SUBJ: New Version 8 of the Sound Operating System (O/S)* for the White Star CPU/Sound II Board * This new version O/S 8 is compatible with all previous versions of CPU/Snd II ROM's.

S.B. Nº 157 Page 1 of 2 Want Service Bulletins by eMail? Request by eMail: parts.service@sternpinball.com

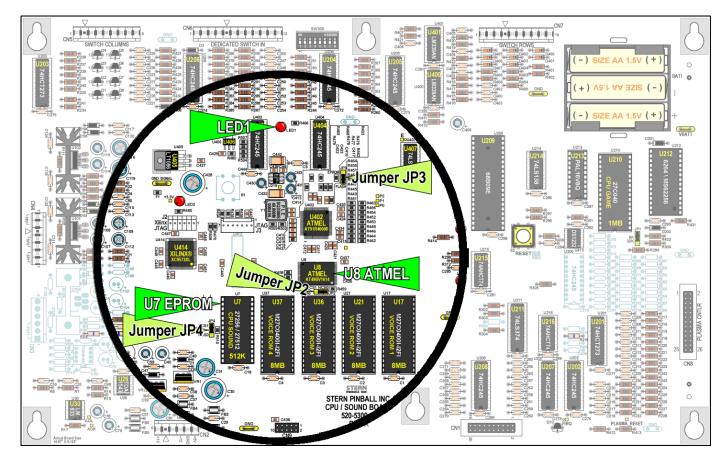
No sound *or* static and noise in place of normal sounds. These symptoms typically occur <u>after</u> swapping sound ROM's between different model games using different versions of the **Operating System** (O/S) (see table below).

T3TM was the first game to start using the *new* White Star CPU/Sound II Board (SPI Part Number: 520-5300-00). This PC board utilizes new hardware in the sound section. This hardware required a *new* **Operating System** (O/S) in software that has been continually improved and updated since **T3**TM. This has created some compatibility issues between the different versions of **Operating Systems**. One example would be games using sound ROM's programmed to work with O/S **5** will not work correctly in a board programmed with O/S **4**. The version of the O/S can be identified by the **number of times LED1** flashes upon power-up (*e.g. The* LED1 will *flicker* then *flash* 4 times = O/S 4, ... 5 times = O/S 5, etc.). Note: Color dots** are used on the IC in position U8 to also determine O/S Version for boards.

** WHEN DETERMINING WHAT OPERATING SYSTEM THE CPU/SOUND BOARD II HAS, USE THE FLASHING LED1 METHOD AND NOT THE COLOR DOT(S). SOMEONE MAY HAVE REFLASHED THE BOARD AND DID NOT CHANGE THE COLOR DOT(S). WHEN REFLASHING YOUR BOARD, BE SURE TO CHANGE THE COLORED DOT(S) ON THE U8 IC PER THE TABLE BELOW.

Reboot your Flash Memory (**U8** IC) with a **U7** Bootflash EPROM. Our software department has released the new Sound Operating System O/S 8 Version (which is compatible with **all** White Star CPU/Sound Board II U7 Sound EPROMs).

- Step 1: Turn Pinball Game OFF (remove backglass for procedure). Reference the above CPU/Sound Board II Component Layout drawing for the locations of U7, JP2, JP3, JP4 and LED1.
- Step 2: Remove the current Sound EPROM at U7 and replace with Bootflash O/S 8 Sound EPROM in its' place.
- Step 3: Move the jumpers at locations JP2, JP3 & JP4 to the opposite position.

- **Step 4:** Turn Pinball Game **ON**. Wait for **LED1** to start flashing continuously (*this indicates flash procedure was successful*). *Note: This usually takes a few minutes.*
- Step 5: Turn Pinball Game OFF.
- Step 6: Remove Bootflash O/S 8 EPROM at U7 and <u>replace with original</u> EPROM you had just previously removed.
- **Step 7:** *IMPORTANT!!* >>> Move Jumpers **JP2**, **JP3**, **JP4** back to their original positions. (*JP2* = *RIGHT*, *JP3* = *BOTTOM* & *JP4* = *TOP*)
- Step 8: Turn Pinball Game ON. Watch LED1 upon power-up. The LED1 will *flicker* then flash 8 times.
